FISHKILL AVENUE SEWER & WATER REPLACEMENT

ADDENDUM No. 1

CITY OF BEACON DUTCHESS COUNTY, NEW YORK

COB Bid No. 2025-007 COB Contract No. 2025-

> **PAVEMENT** RESTORATION DETAIL

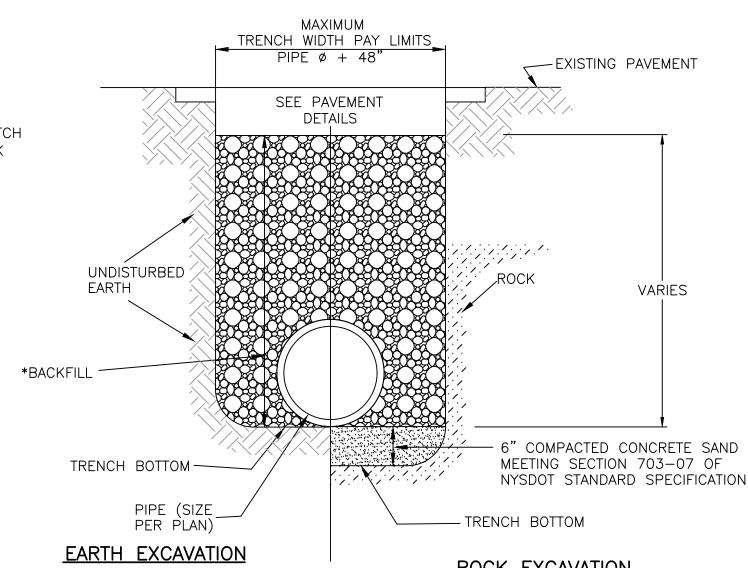
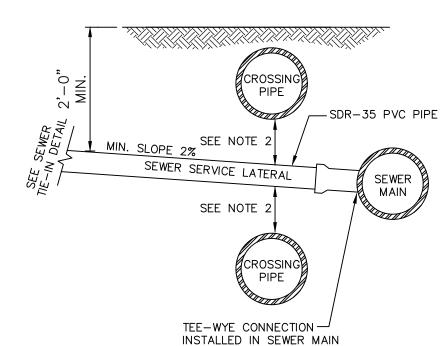
- a. "Utility Trench Cross Section" detail was revised to remove reference to milling, and thicknesses of proposed pavements for trench restoration depending upon location.

- 2) The pavement restoration details that are part of the trench cross section detail on Sheet 7 of 9 have been revised to reflect the pavement thicknesses noted in the bid form.

- 3) The 1 ½" top course pavement previously shown on the trench restoration detail has been removed. The only top course pavement for the project would be that in driveways and parking lots.

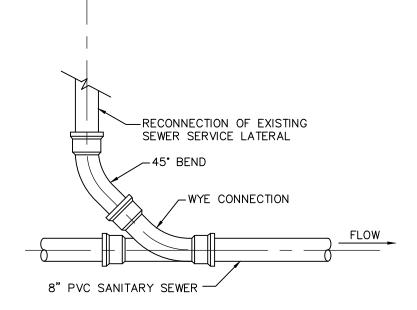
- b. Sidewalk and Curbing details were revised to include a note with regards to the required sealing of the concrete, and curbing adjacent to sidewalk, on sidewalk detail, was removed.
